Re: **BID ADDENDUM No. 2**
Phase 1A – Bond Improvements
Bedford Central School District
SED No. 66-01-02-06-0-003-021 (FLHS)
SED No. 66-01-02-06-0-007-011 (FLMS)
SED No. 66-01-02-06-0-006-015 (MKES)
SED No. 66-01-02-06-0-002-016 (BVES)
SED No. 66-01-02-06-0-004-020 (BHES)
SED No. 66-01-02-06-0-009-014 (WPES)
SED No. 66-01-02-06-0-001-016 (PRES)
BBS File No 22-225A-G

The following changes shall be and are hereby made:

SCALE: 1/8" = 1'-0"

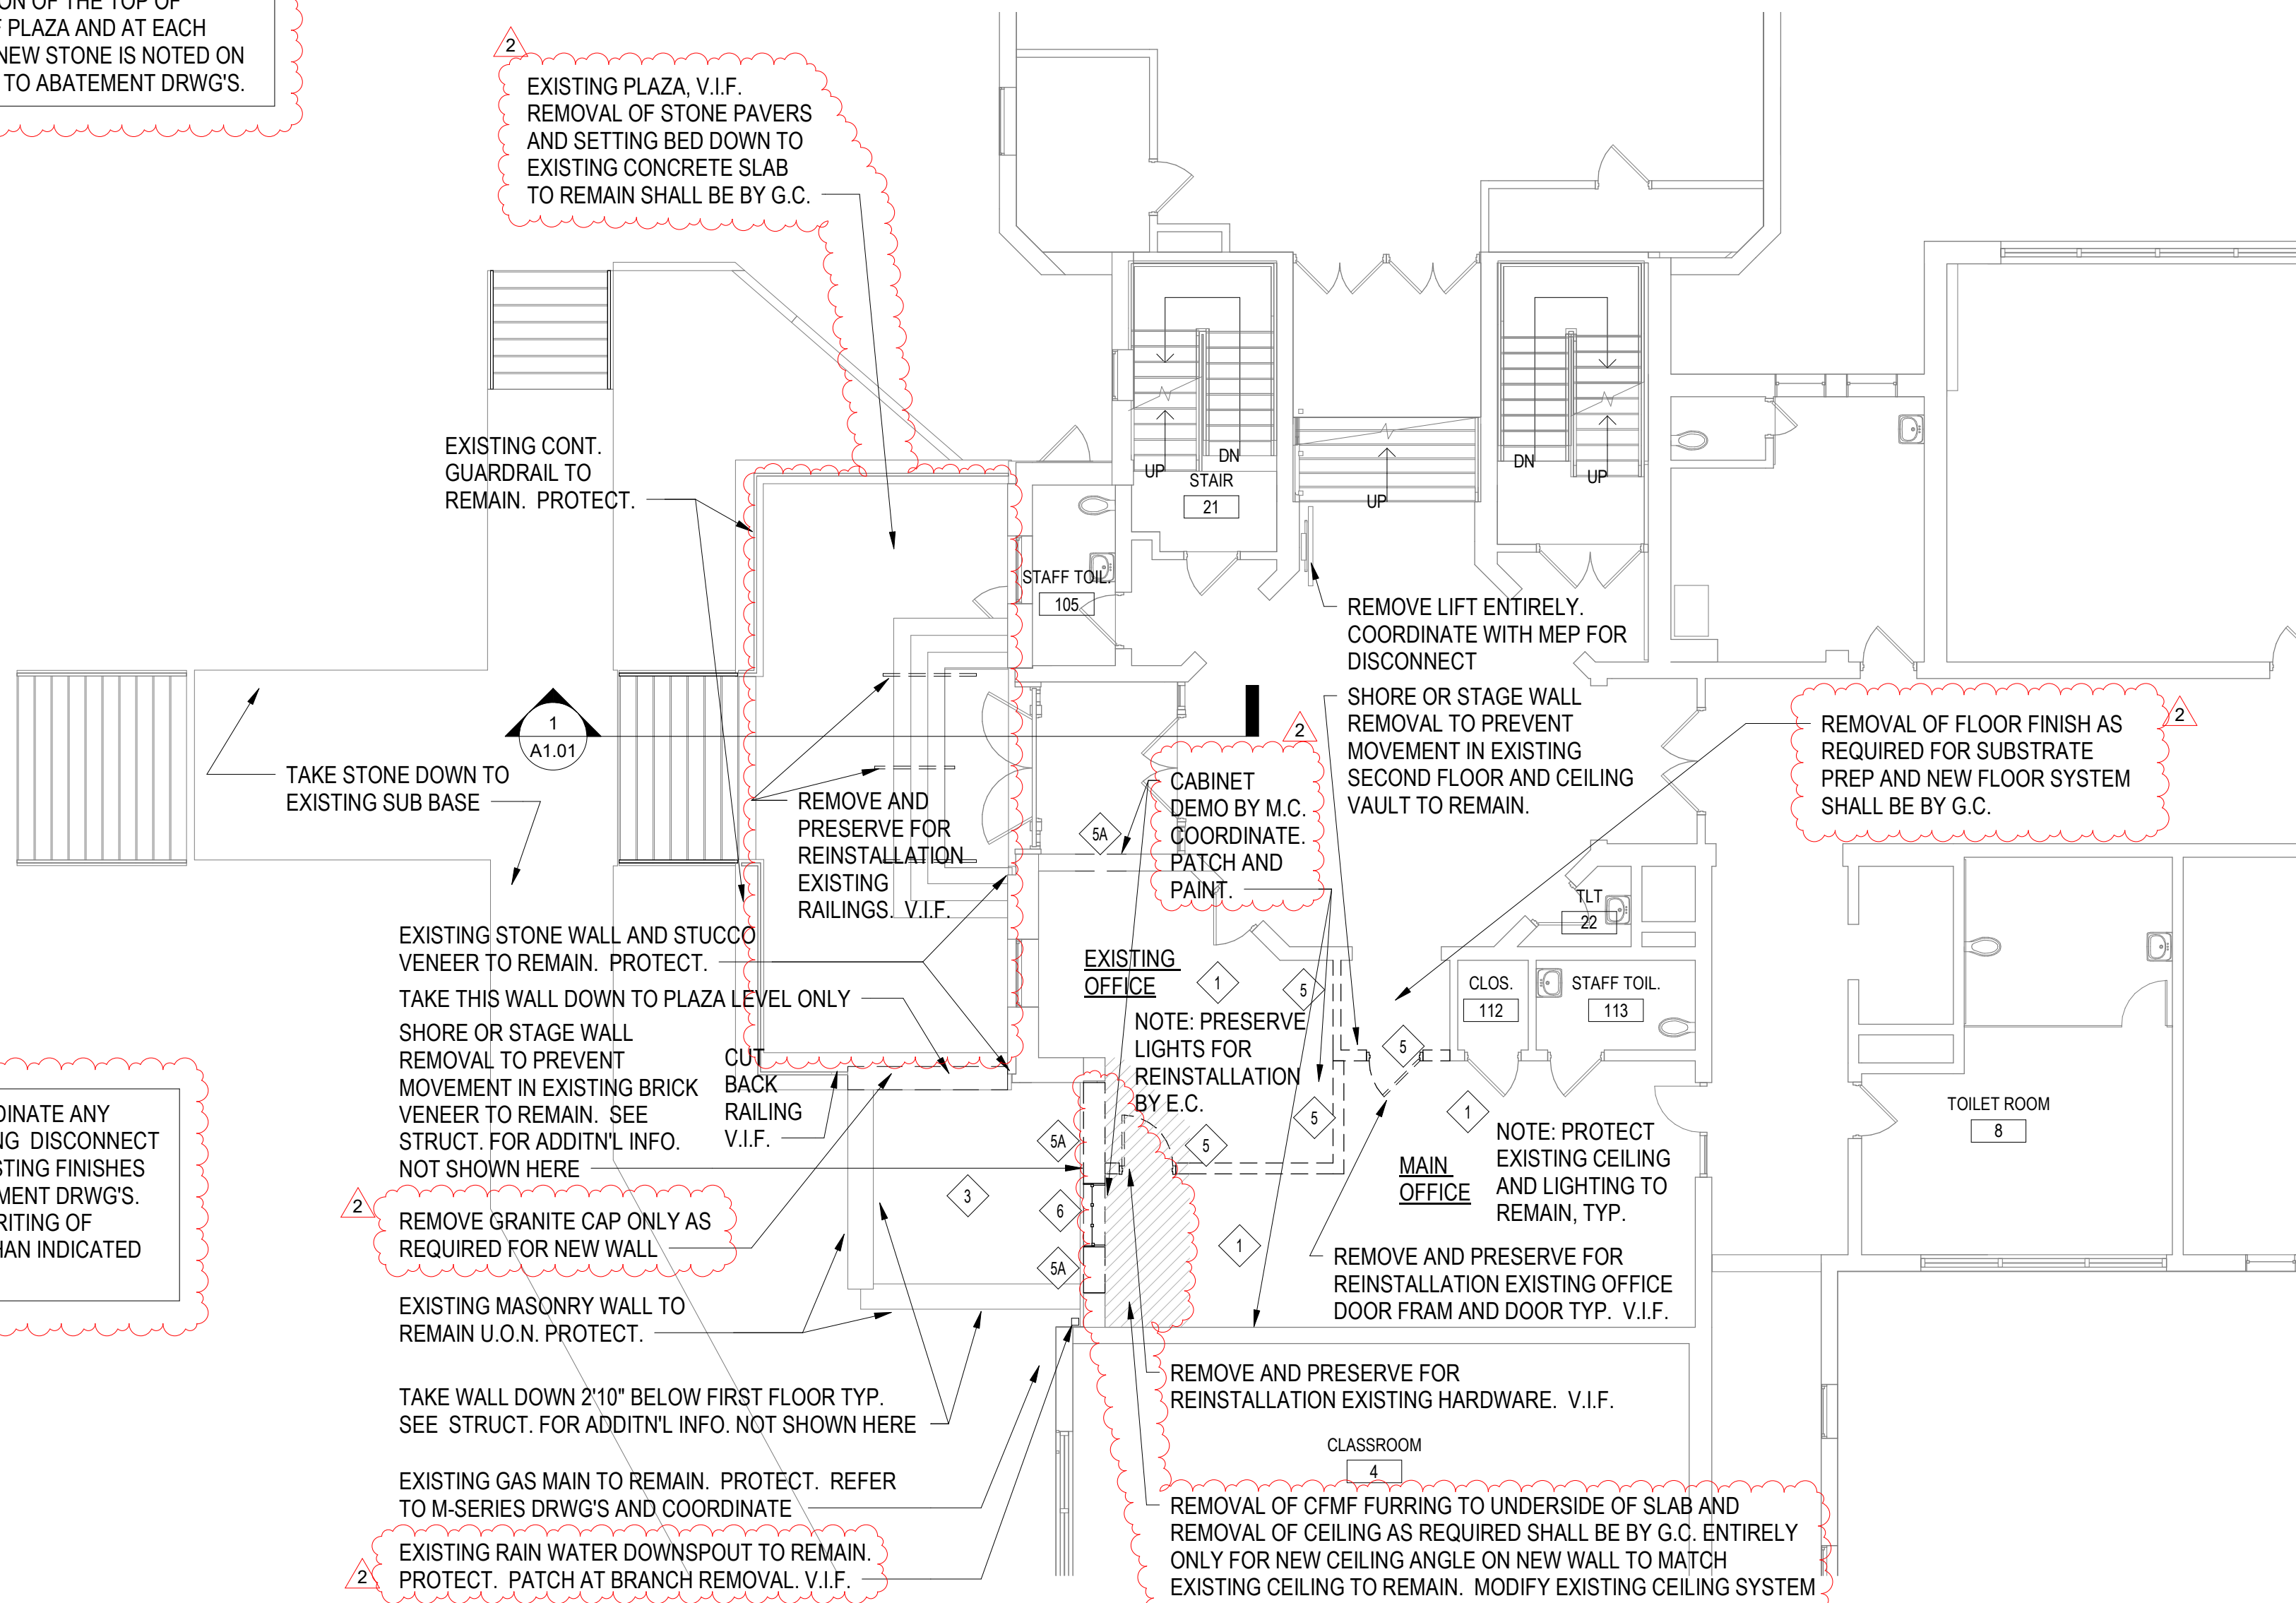
Drawing A1.01 MKES, section 3 notes existing drywall ceiling and VCT floor to remain and protect. Drawing A2.01 MKES, section 1 and 3 shows new ACT drop ceiling and LVT/VCT/T1 floor finishes. Please confirm existing ceiling and walls remain and new finishes installed over existing.

BBS Response: Refer to revised drawing.
